**PUBLIC INTEREST REVIEW FOR GROUNDWATER APPLICATIONS**

TO: Water Rights Section Date 02/06/2015  
 FROM: Groundwater Section Michael J. Thoma / Gerald H. Grondin  
Reviewer's Name  
 SUBJECT: Application G- 17960 Supersedes review of \_\_\_\_\_  
Date of Review(s)

**A. GENERAL INFORMATION:** Applicant's Name: Stuart & Meggan Hills County: Baker

Figure 1: Application overview map showing proposed POAs, existing PODs, and nearby wells (some wells placed in center of quarter-quarter based on location provided on driller's log); values of "0" in "Completed Depth" and "First Water" indicate no data.

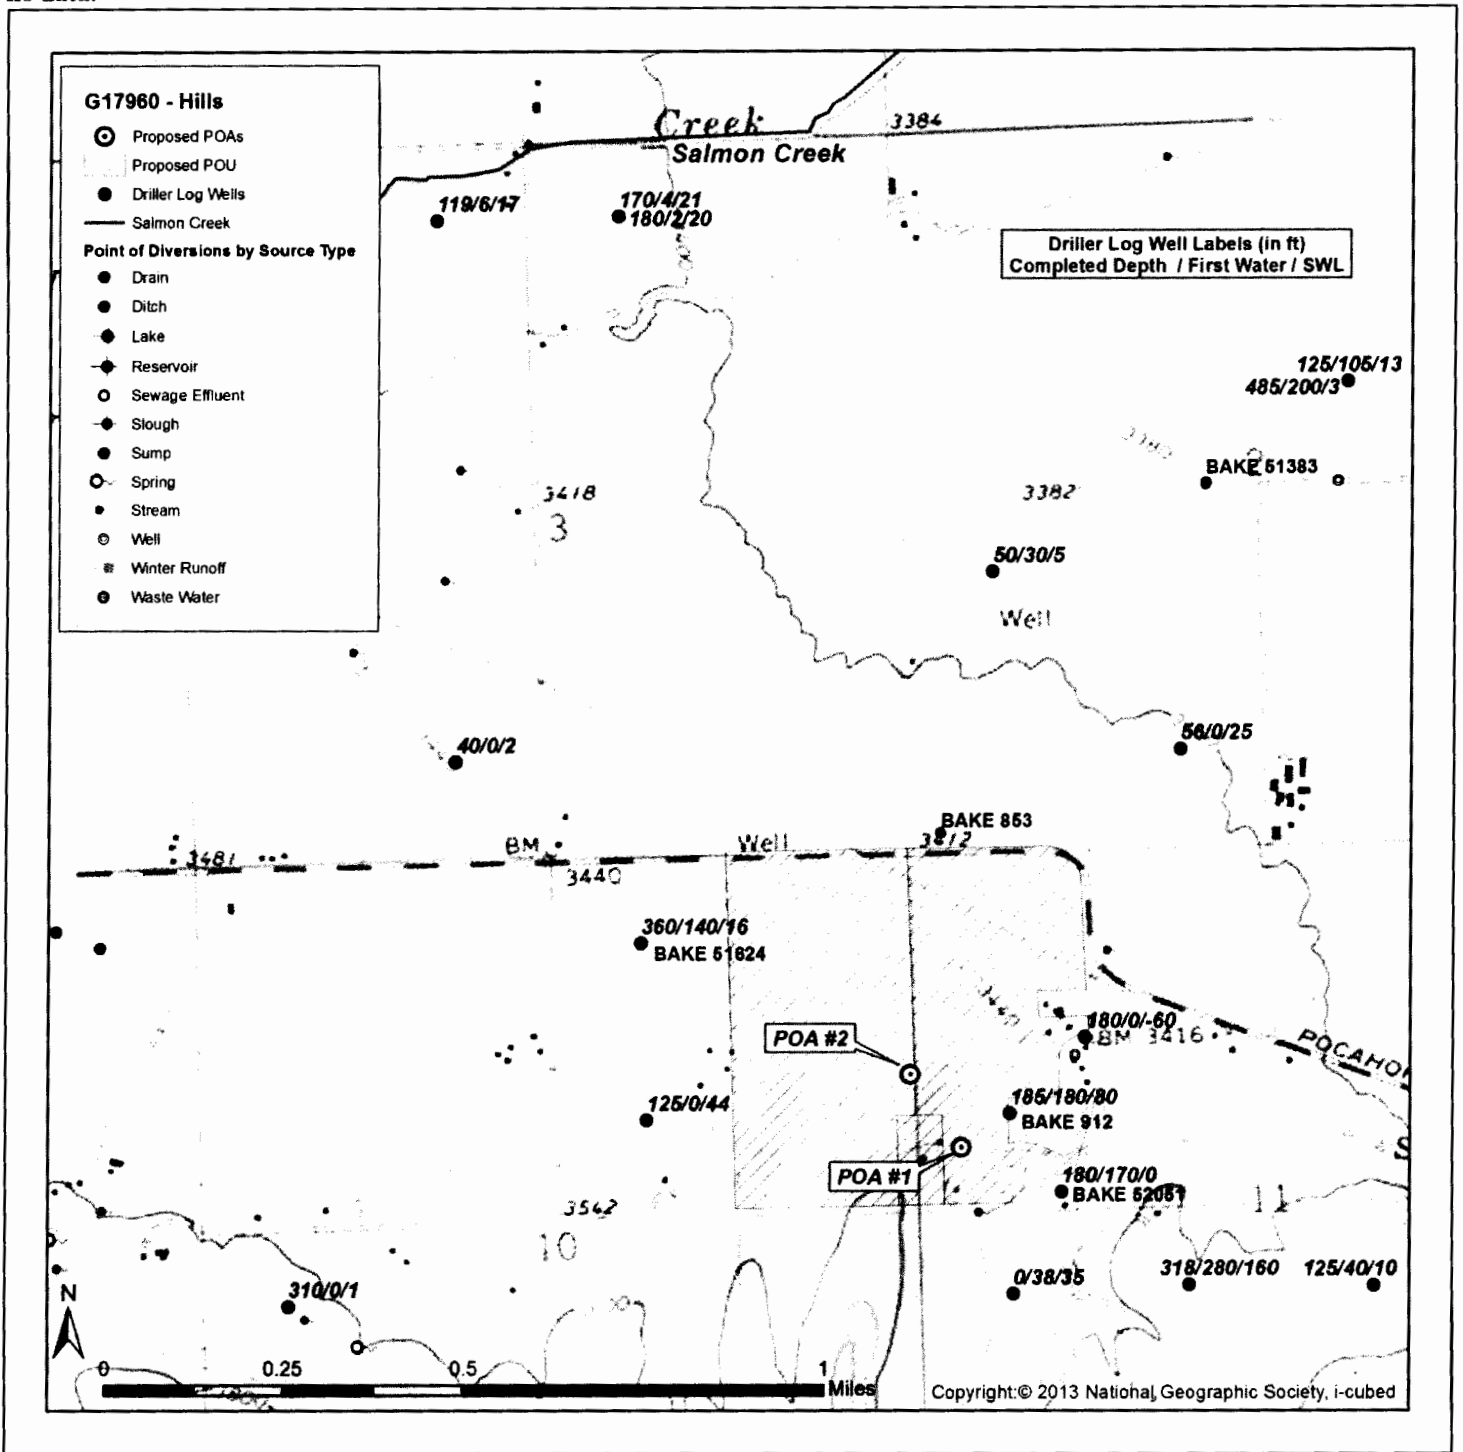
**Basis for aquifer hydraulic connection evaluation:** The wells in this area and at the depths proposed by the applicant are confined, but wells near Salmon Creek show “first water” depths within 10 ft of land surface (see **Figure 1**) implying hydraulic connection between the creek and the shallow portion of the aquifer, and saturation of the aquifer from near the surface through the full thickness. Additionally, there are several surface water diversions on Salmon Creek and as it has low flows in the summer months (< 5 cfs), even small impacts could have considerable effects. Despite the finding of hydraulic connection, however, the presence of thick, shallow clay layers reported in driller’s logs and the distance between the proposed POAs and Salmon Creek should greatly reduce the efficiency of hydraulic connection and the overall impact to Salmon Cr. (see C4a and **Figure 3**).

Figure 2: Temporal water level data from two nearby wells: BAKE 51383 and BAKE 853

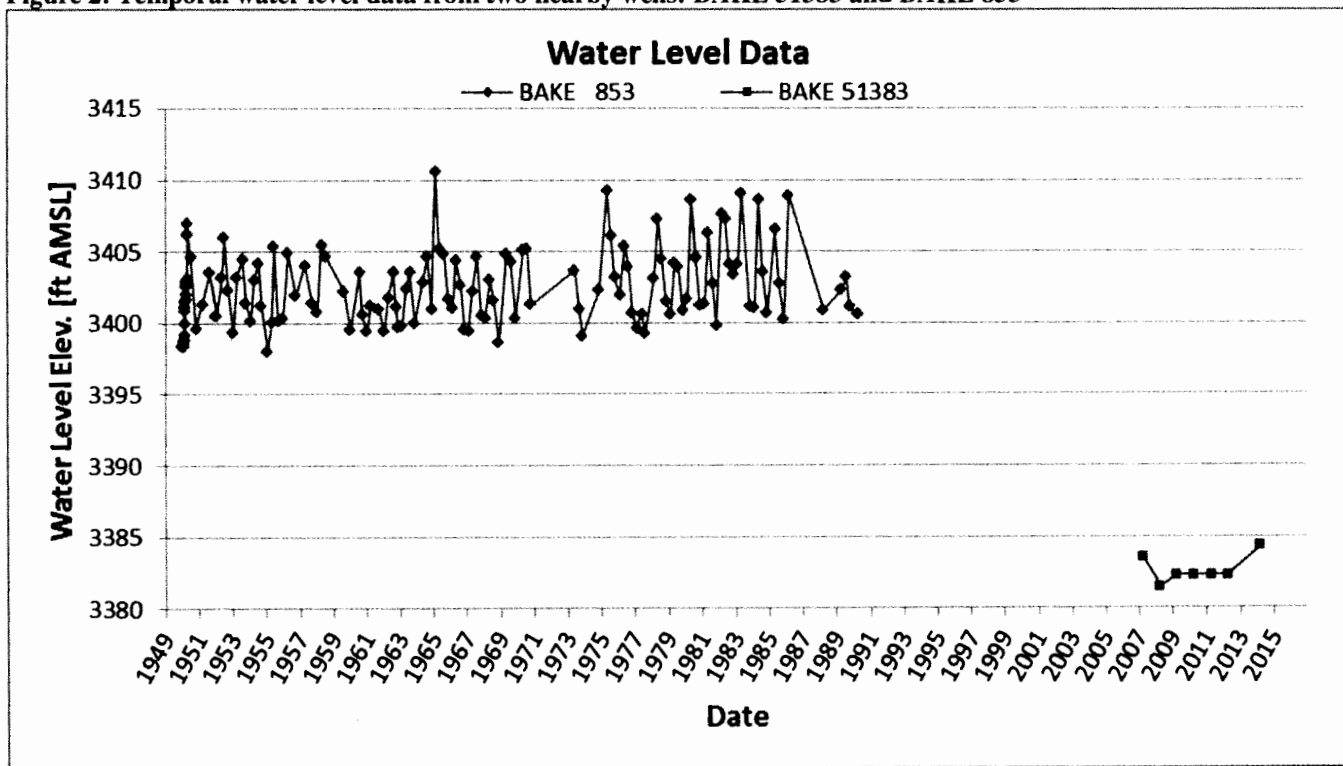
There are two wells nearby that are/have reported annual water levels (BAKE 853 from 1949-1990 and BAKE 51383 from 2007-2014). Both show stable WL trends (Figure 2). Although WLs do not show declines in these two wells, it is not sufficient evidence to declare that groundwater is not over-appropriated.
